Canada Bay Bicycle User Group Inc
Incorporated in NSW under the
Associations Incorporation Act 2009 as INC9882364
Affiliated with Bicycle NSW Inc.
E-mail - secretary@baybug.org.au
Website: - www.baybug.org.au
Correspondence to:
The Secretary
Geoff Ashton
52 Iandra St
Concord West NSW 2138 Australia
Mobile: 0407006874

4 May 2022

Submission on the Environmental Impacts Statement for Metro West - rail infrastructure, stations, precincts and operations – Westmead to the Sydney CBD

Figure 1 Concept of Shared Zones at Five Dock

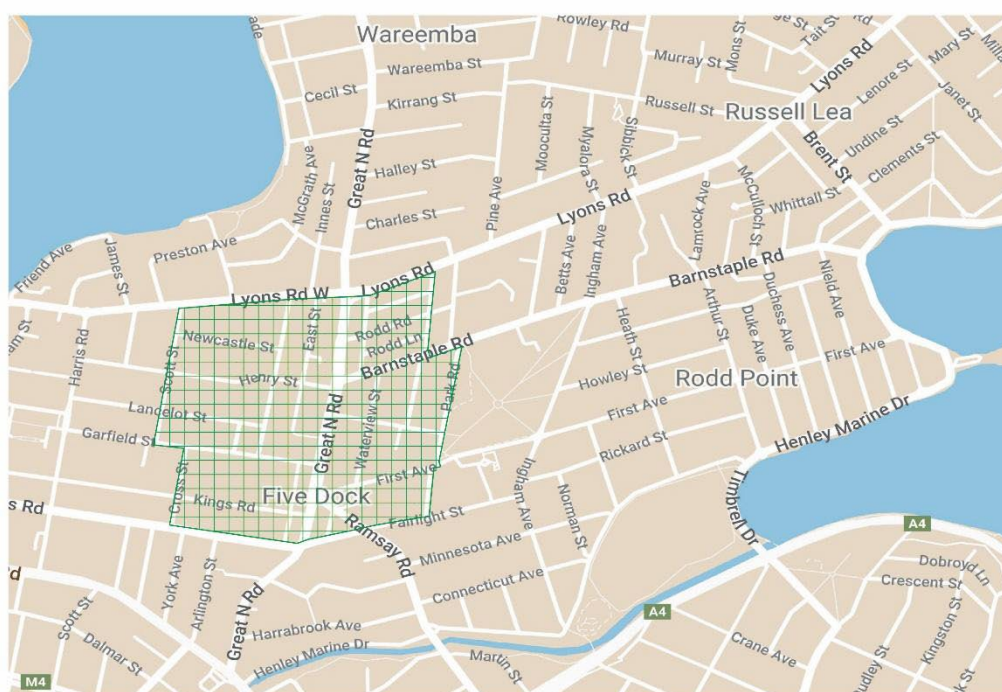
BayBUG suggests that shared zones be established on:

- **East Street, at the back of the Five Dock Station, and**
- **Garfield Street at the Kiss and Ride drop point that leads to Thompson Lane and Fred Kelly Reserve, to improve safety for passengers.**

Below is a figure of the suggested shared zones.

Figure 3 Concept of Shared Zones at North Strathfield

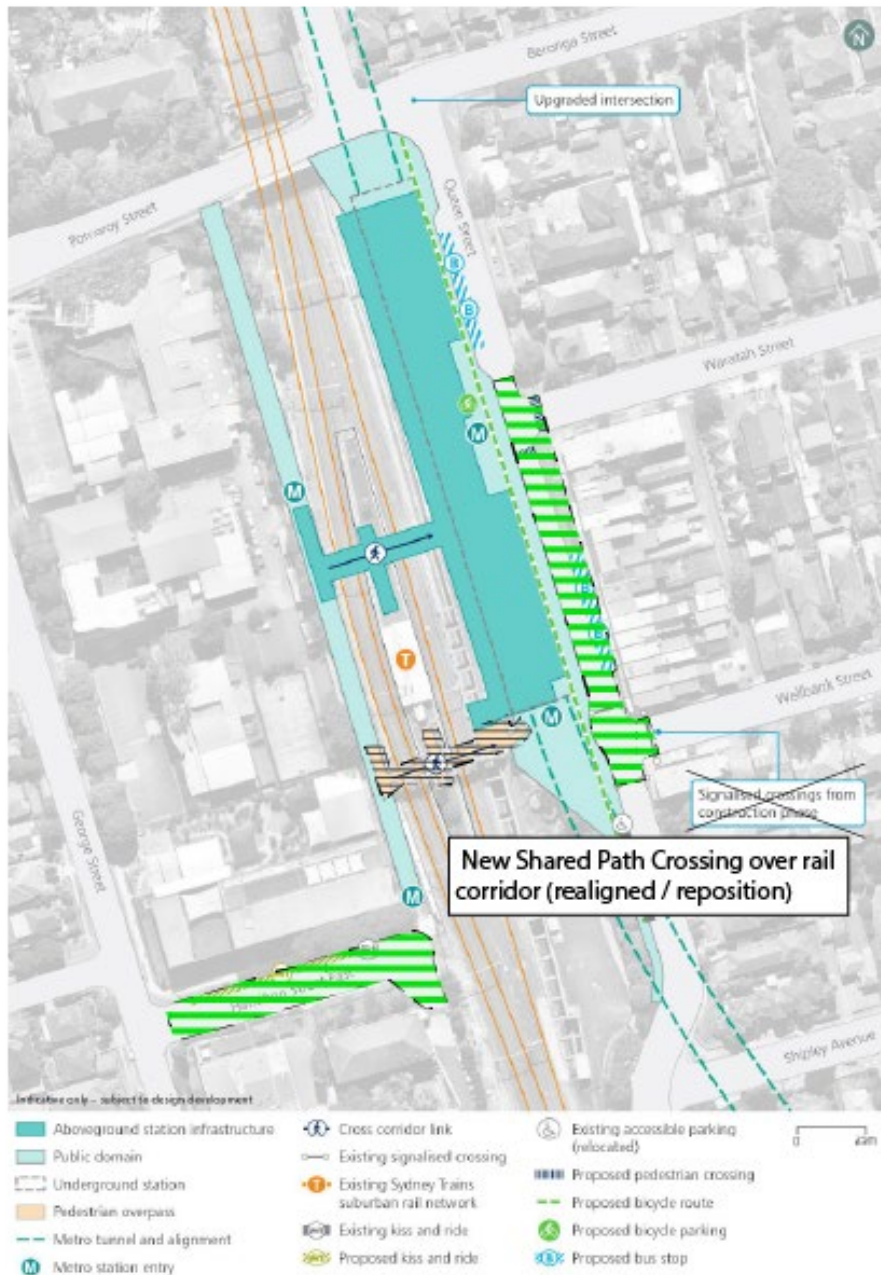
The proposed Metro West cycleway on Queen St runs for approximately 320m along the eastern side of the station. However, there is no indication that it connects to any other local cycleway.

The East-West Regional Cycleway terminates at the junction of Patterson St and Concord Road at North Strathfield.

BayBUG suggests that the Metro West station design include a shared path along Princess Ave with a separated on-road cycleway along Queen St to connect the East-West Regional Cycleway to North Strathfield Station.

BayBUG presents the following figure as a concept for shared zones at North Strathfield.

Figure 4 Concept of Shared Zone and Raised Pedestrians Safety platform at Burwood North

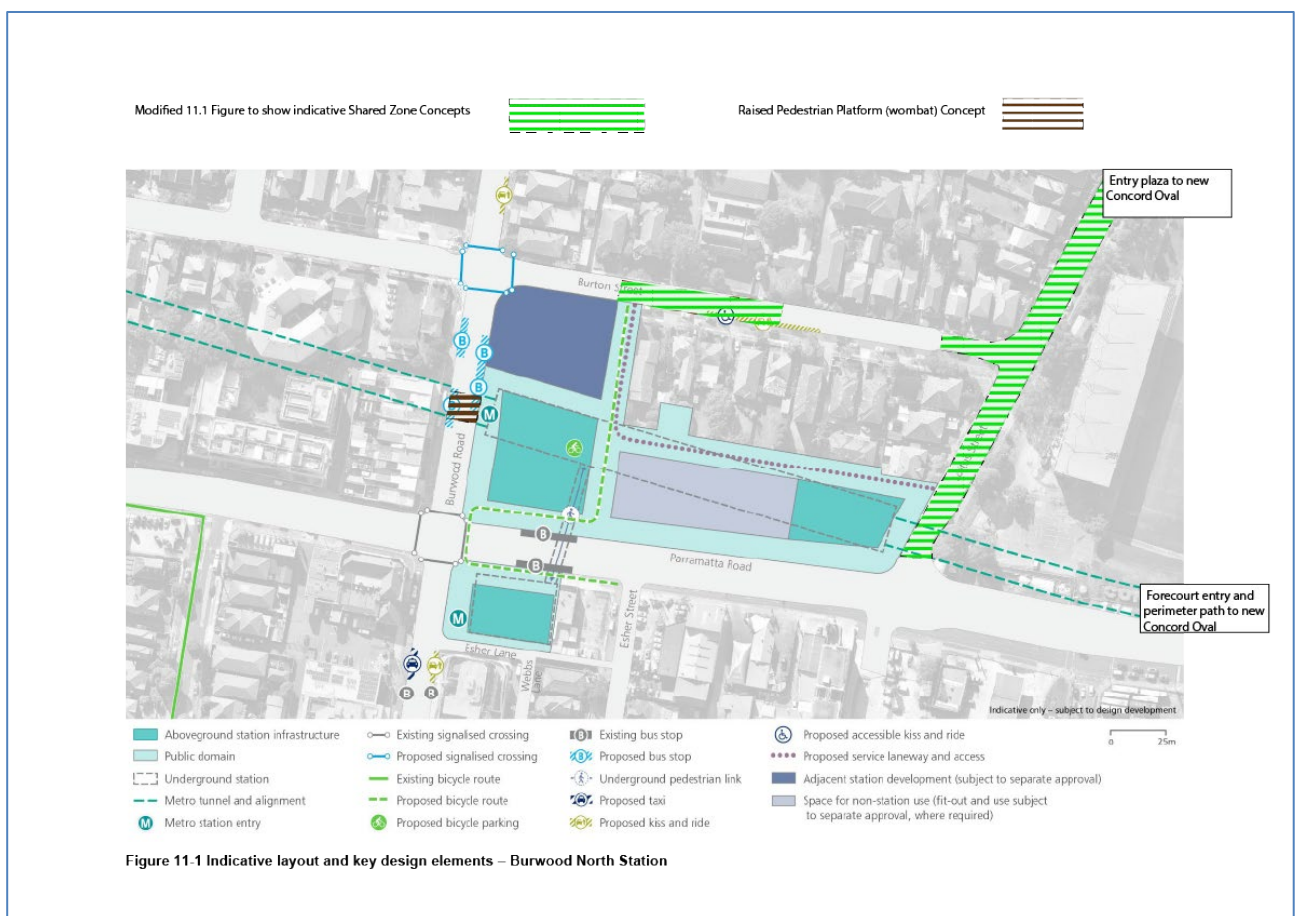
The EIS indicates bus interchanging on Burwood Road, outside the Metro West entrance, yet there is no pedestrian flow diagrams to indicate how passengers transferring to / from north-bound bus services will access / egress the station. Presumably they will have to walk up the proposed new traffic signals on Burton St / Burwood Rd intersection and walk back.

BayBUG does not believe this fulfils the priority requirement for bus interchanging.

BayBUG presents the following figure as a concept for shared zones and raised pedestrian safety platform at Burwood North Station.
